E4416A-12A

S E R V I C E N O T E

Agilent E4416A EPM-P Peak & Average Power Meter

Front Panel Display Problems Caused by Power Assembly Cable

PSU cable assembly, E4418-61029

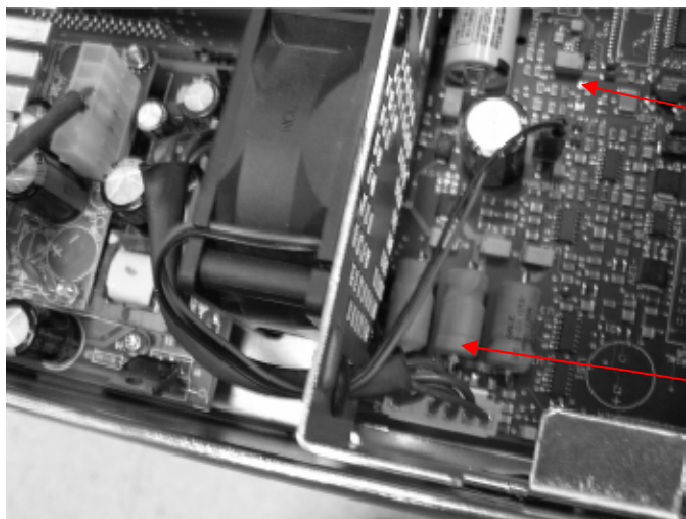
- 3) Remove fan connector and PSU cable assembly.

New cable with RED color

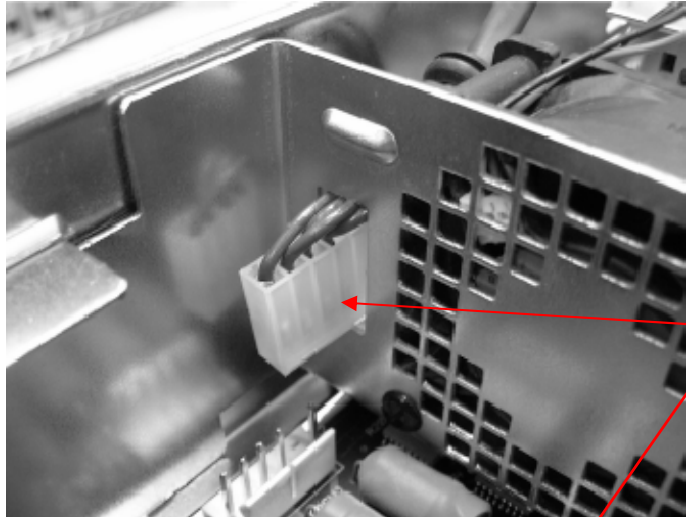
- 4) Replace with new PSU cable assembly E4418-61029. You can differentiate the cable assembly by the colors. The old cable is Black and new cable is RED.

Put back fan connector

Insert the plastic casing horizontally

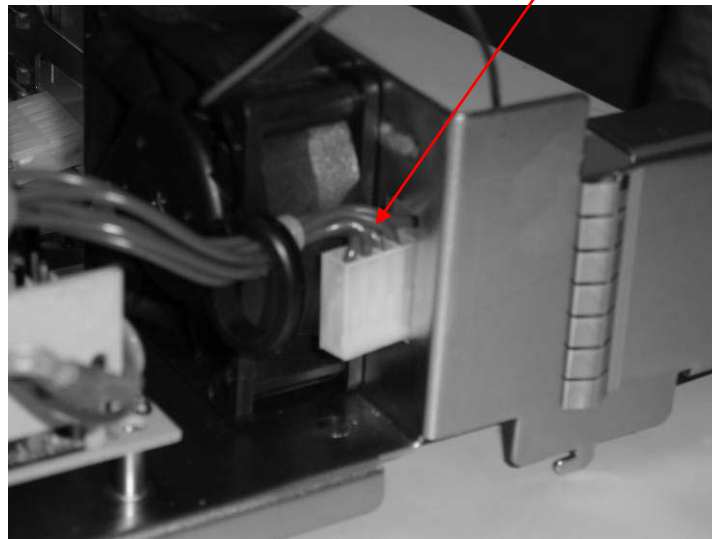
- 5) Place back the power supply shield.
- 6) Place back the Cover, Handle and bumpers.
- 7) Here are some tips regarding the new cable. Since the plastic casing is slightly bigger in size, so you cannot directly pass through connector through hole. So you need to insert the cable horizontally. See illustration below.

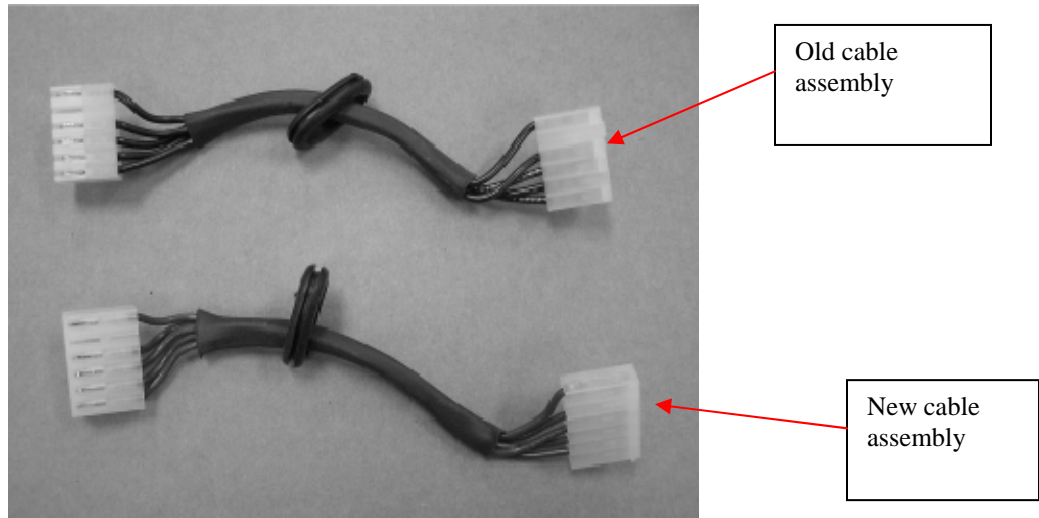
- 8) Photo below show different of old and new cable. The new cable is red in color whereas the old cable is black in color.

Note: If the power cable assembly is red in color, indicates that the cable already been changed. No action is needed.
